The Glade of Light

Design Update

06.05.21

Seating Layout

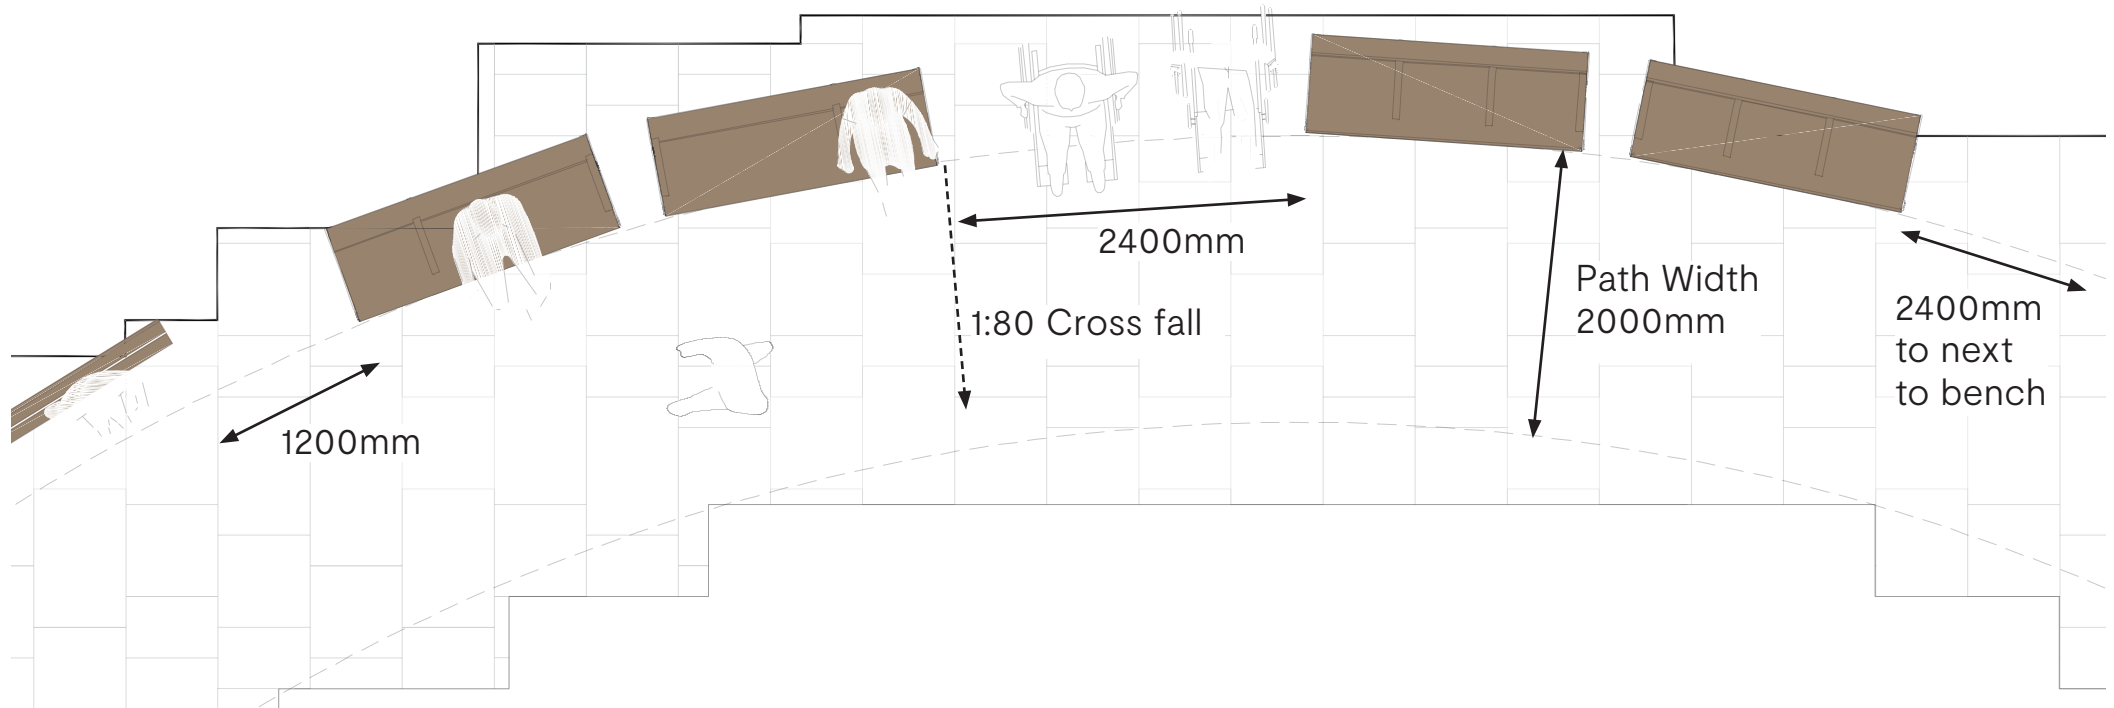
The updated seating layout allows for larger gaps for wheelchair users and incorporates higher perch seating.

Seats have been spaced to allow space for 6 wheelchair accessible gaps.
Seat types

A total of 8 benches in a mix of height and armrest combinations will be provided.

Seating Armrest Types

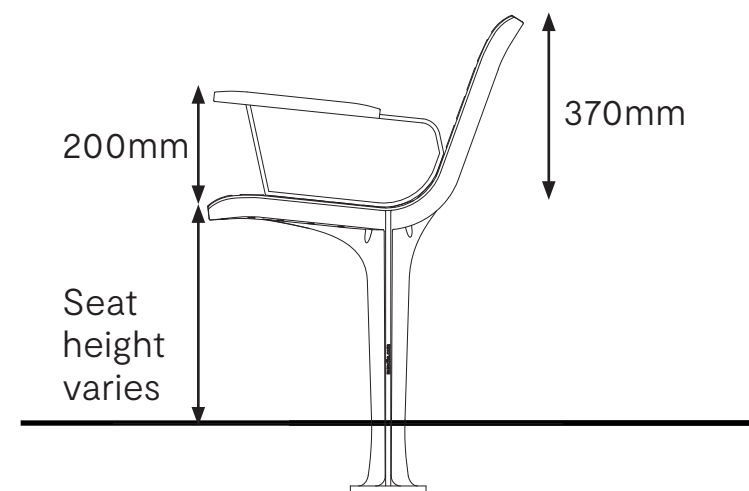
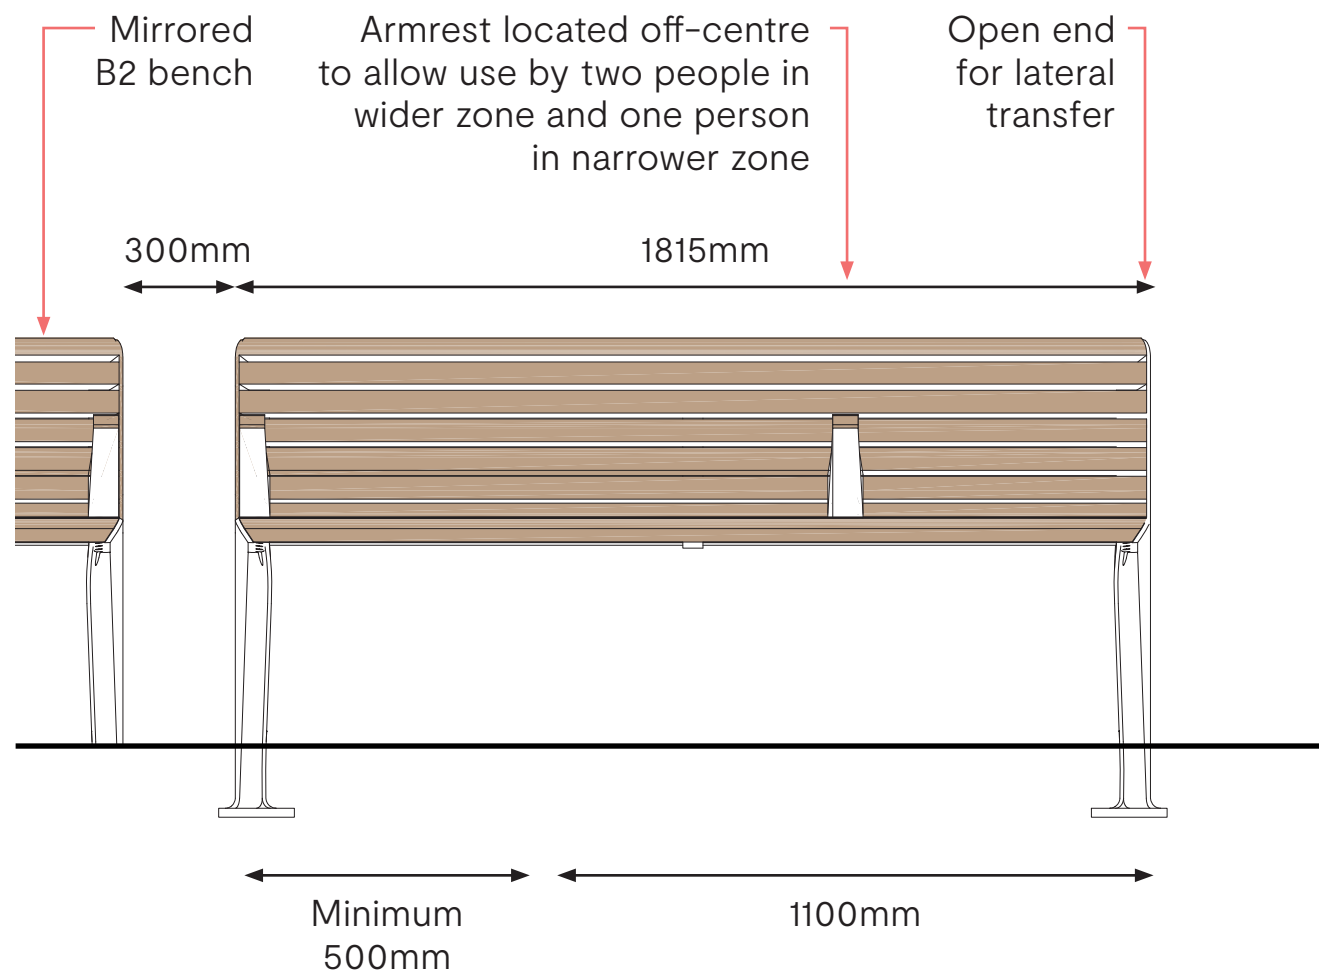
Seat with Armrest:
The protrusion at the front of each armrest
provides additional grip when standing up
Armrests to be rounded at 12mm radius
to all top edges.

Seat Reference B1: Two
armrests - One Open end

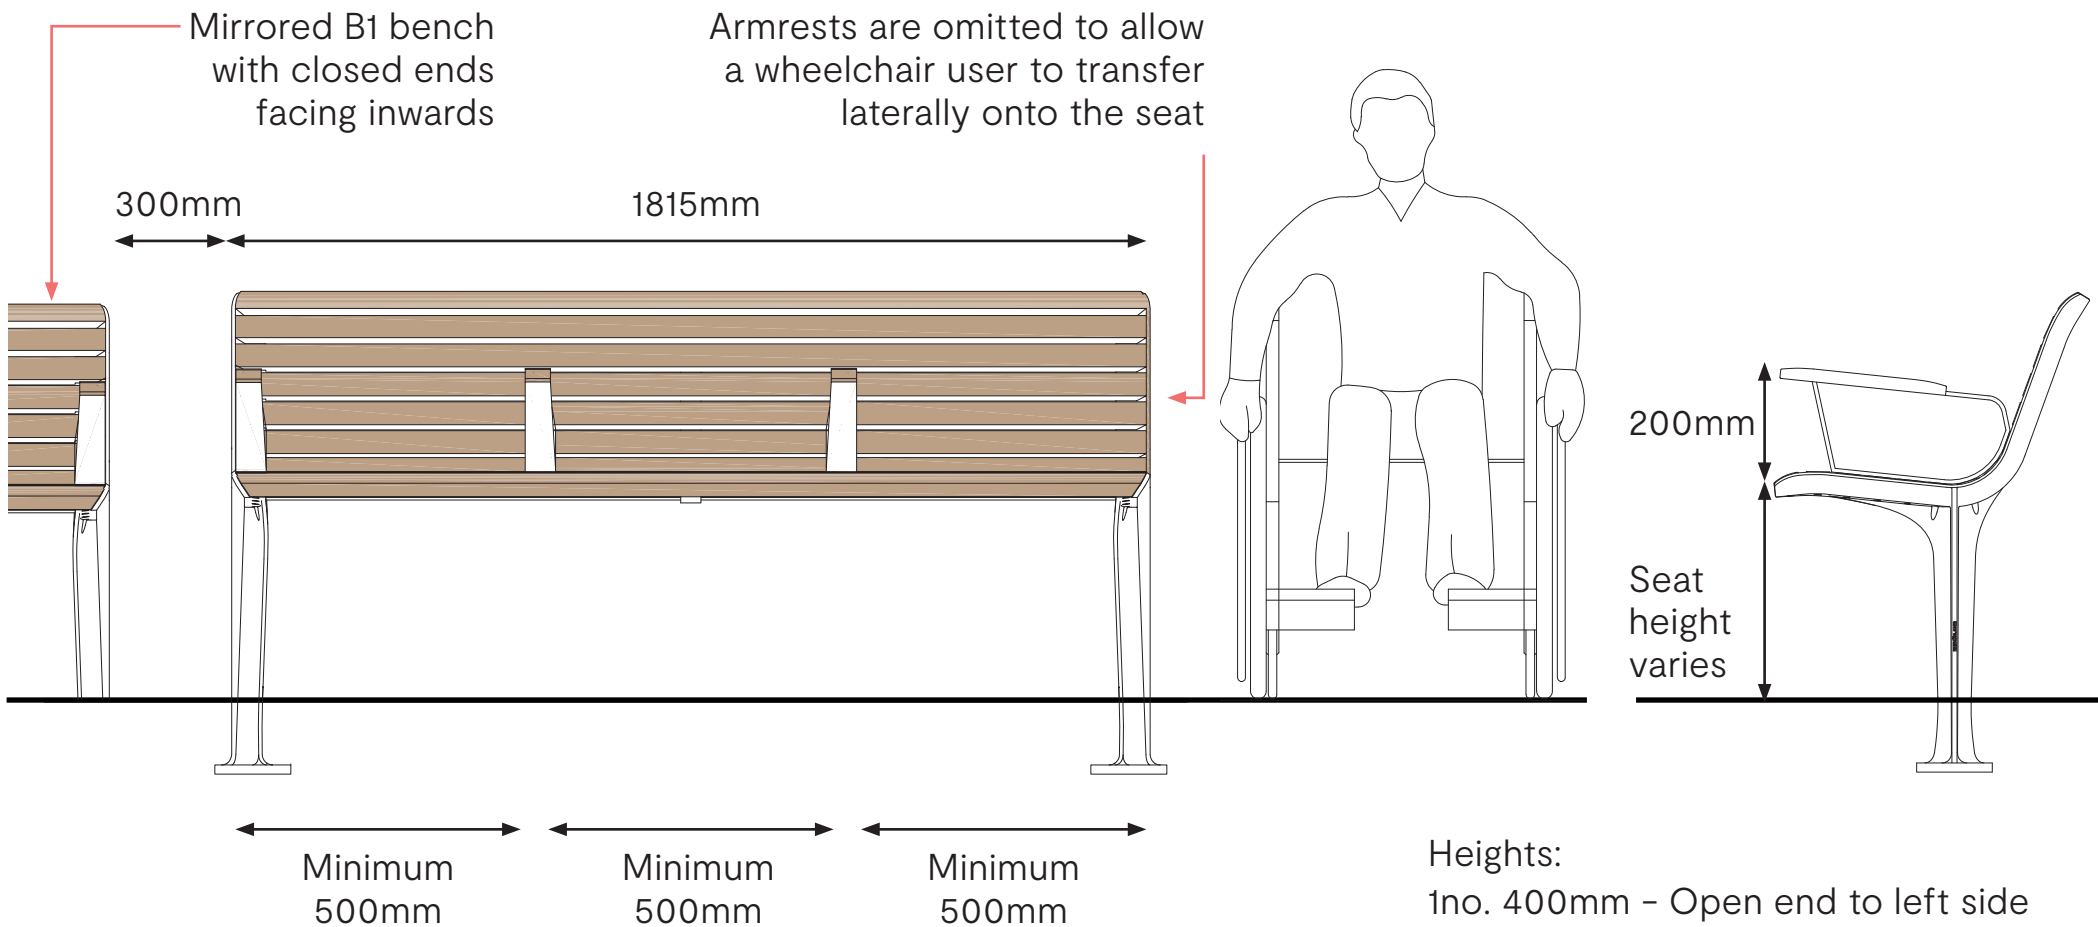
1no. 400mm - Open end to right

1no. 450mm - Open end to left

2no. 480mm - Mirrored open ends

Seat Reference B2:

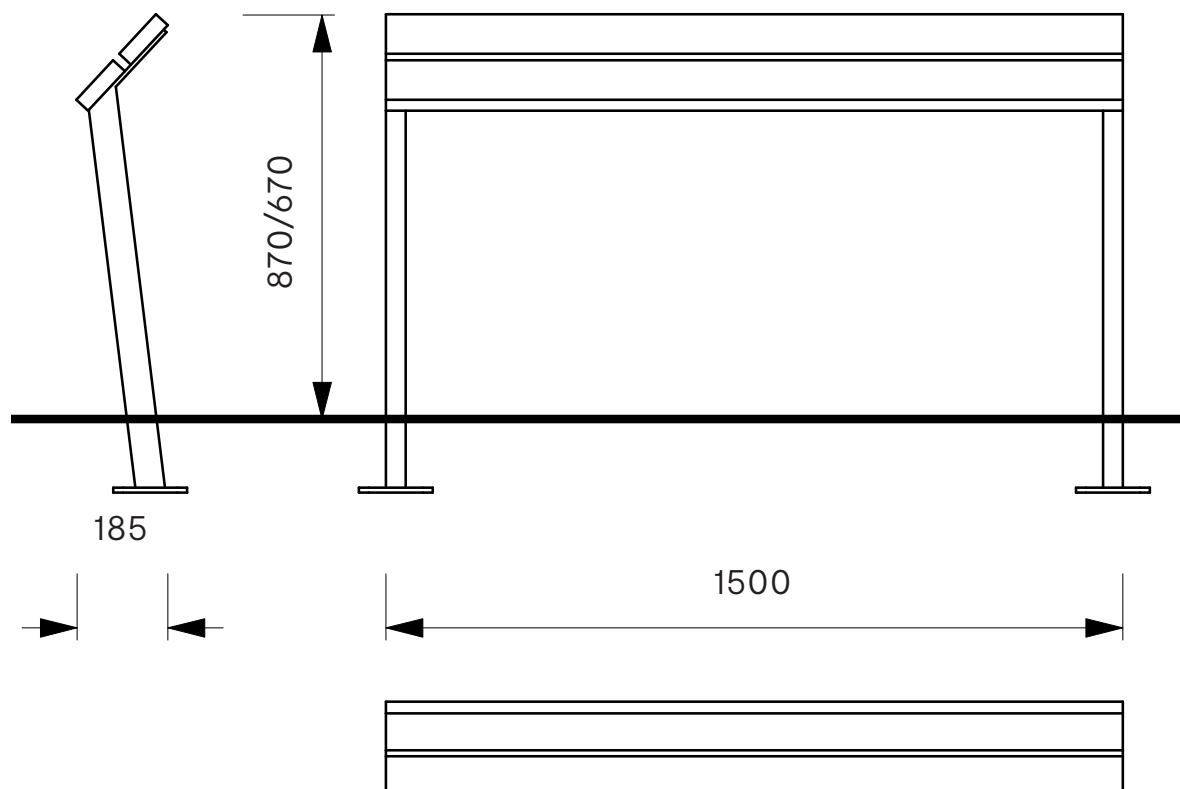
Three Armrests - One open end

1no. 400mm - Open end to left side

1no. 450mm - Open end to right side

Open ends allow for level transfer from wheelchair. Closed ends to face each other where no transfer space is available.
